Department of Energy
National Nuclear Security Administration
Washington, DC 20585

Enclosure: Detailed Response to DNFSB letter of November 19, 2012

In a letter dated November 19, 2012 to the National Nuclear Security Administration (NNSA), the Defense Nuclear Facility Safety Board (DNFSB) identified eight concerns with the Area G safety basis at Los Alamos National Laboratory (LANL). The DNFSB requested a report identifying actions taken or planned by NNSA to resolve these safety issues.

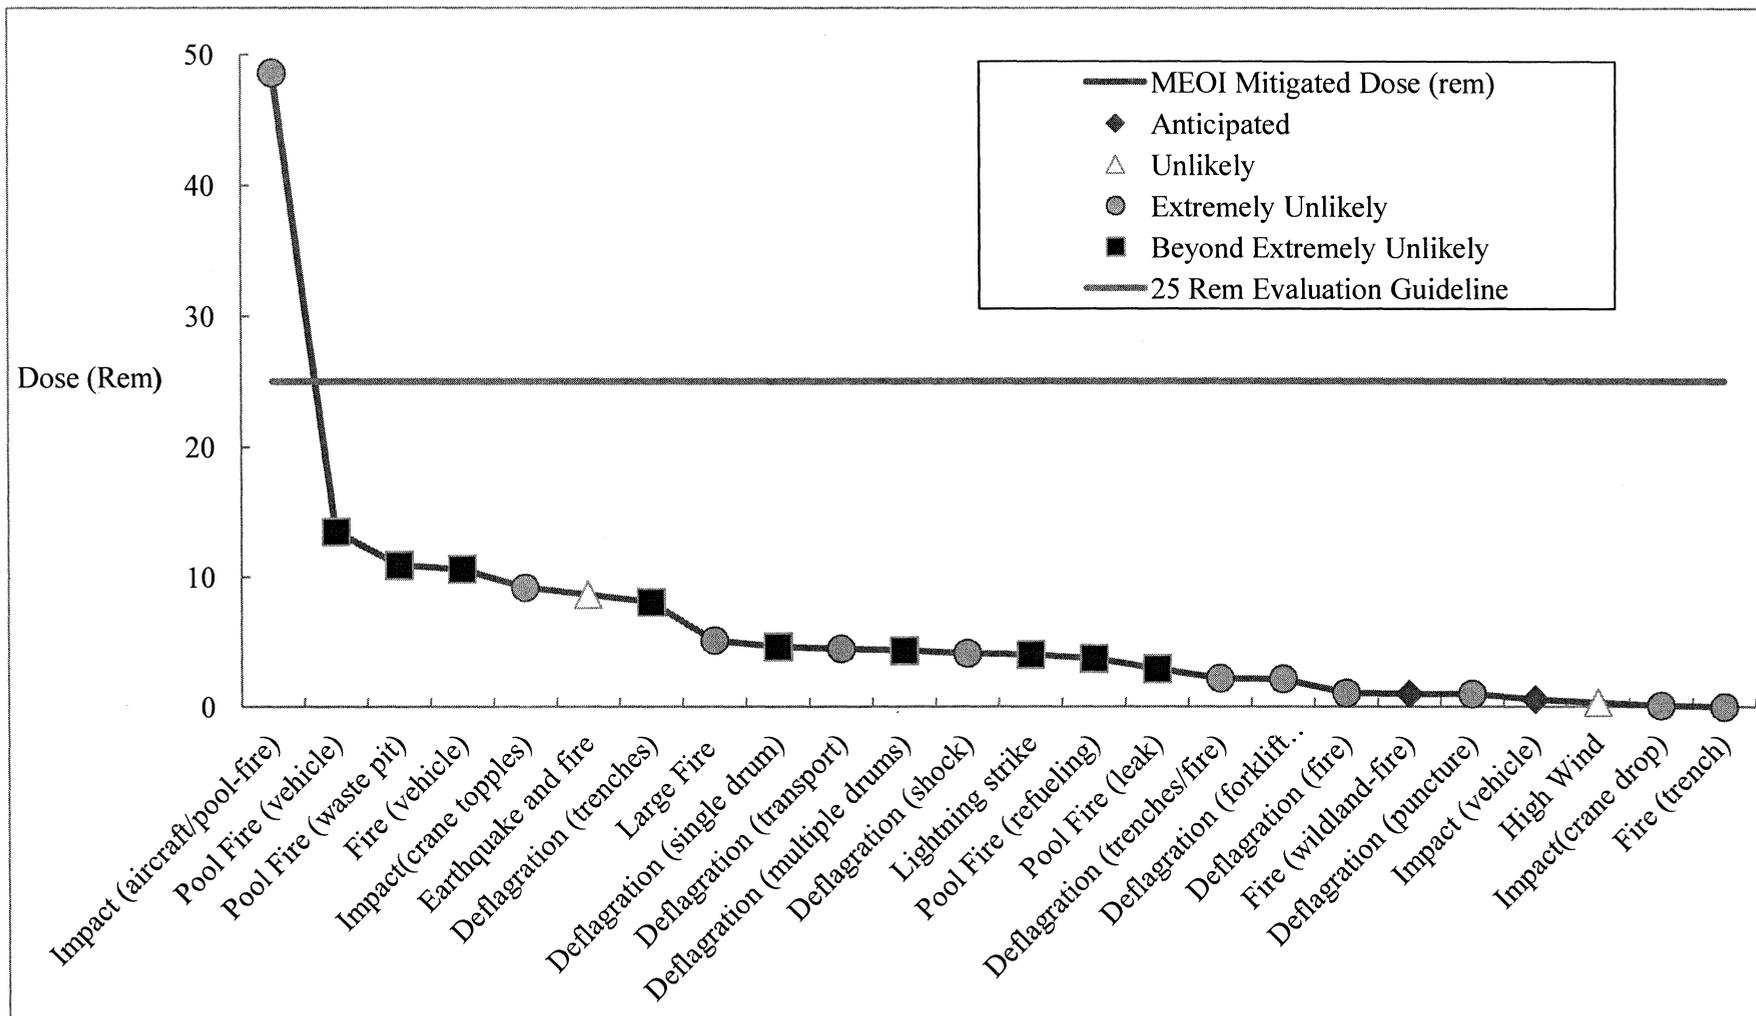
For perspective, Figure 1 presents the calculated mitigated accident frequencies and mitigated doses to the maximally exposed off-site individual (MEOI) for the two dozen detailed accident analyses in the 2012 DSA. The frequency bins (e.g., Anticipated, Unlikely, etc.) correspond to those identified in Department of Energy (DOE) Standard 3009. One accident scenario, the aircraft crash and fire, had calculated consequences exceeding the DOE 25 rem Evaluation Guideline. NNSA accepted this result based on:

NNSA Analysis: The hazard analyses in both the currently implemented and the new but not yet implemented DSA also include deflagration/fire scenarios that are caused by accumulation of flammable airborne concentrations above the lower flammability limit following a gasoline or propane fuel leak or spill. Figure 1 indicates that the 2012 DSA accident analyses included 9 deflagration scenarios and 8 other fire scenarios. The scenarios already covered in the hazard and accident analyses may bound the scenario posed by the DNFSB and its staff.
